PHAP12-00025

Date: August 20, 2012
Application Type: Certificate of Appropriateness
Property Owner: Gilbert & Lizebet Robles
Representative: Gilbert & Lizebet Robles
Legal Description: Lots 23 & 24, Block 100, Government Hills Addition, City of El Paso, El Paso County, Texas
Historic District: Austin Terrace
Location: 4515 Cumberland
Representative District: #2
Existing Zoning: R-4/H (Residential/Historic)
Year Built: 1921
Historic Status: Contributing
Request: Certificate of appropriateness for the construction of a rear patio, relocation of entry stairway, installation of stamped concrete at front and side yards, and improvements to parkway.
Application Filed: 7/23/2012
45 Day Expiration: 9/06/2012

ITEM #4

The construction of a rear patio, relocation of entry stairway, installation of stamped concrete at front and side yards, and improvements to parkway.

LANDSCAPE PLAN

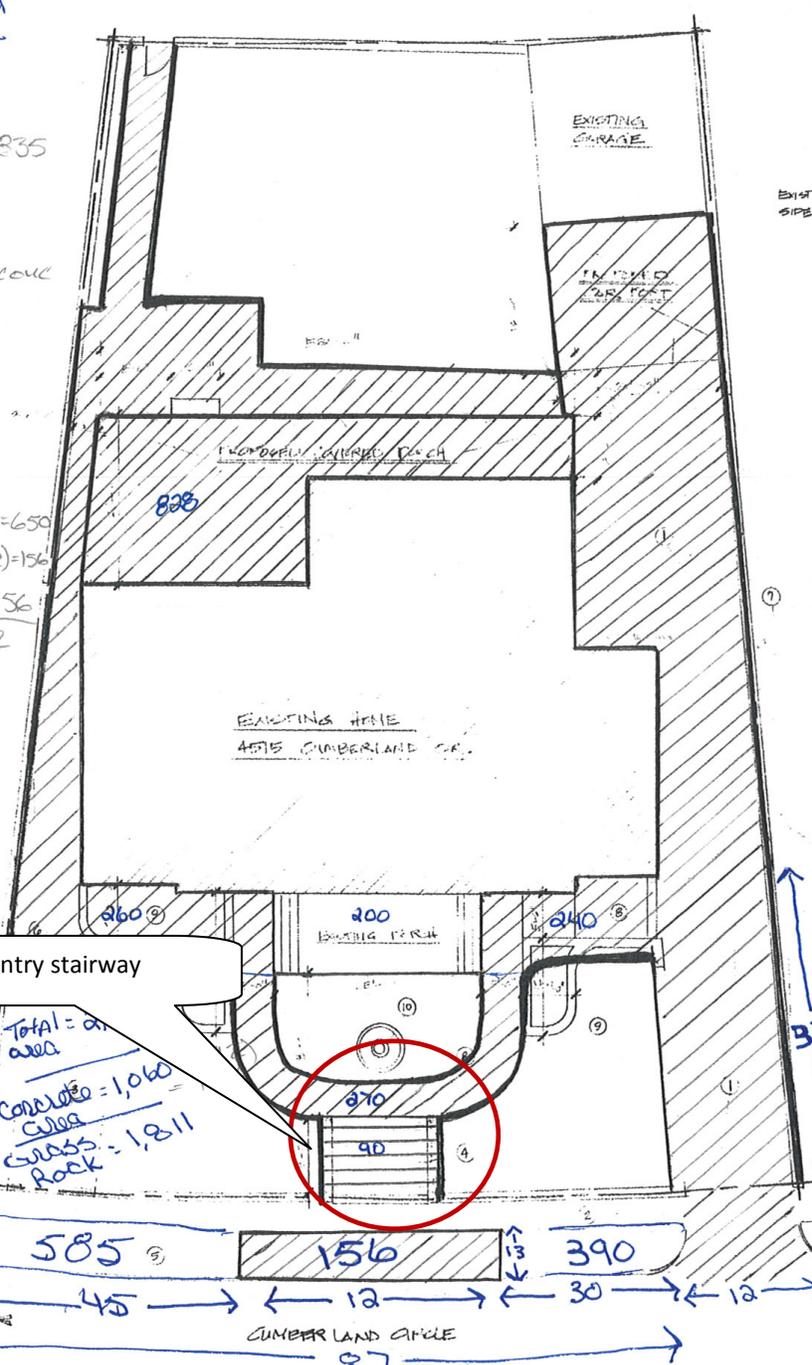
The modifications being requested are that the driveway and walkway be tinted a matching color that is of a natural material and compatible with the building and that they not be coated with a high gloss.
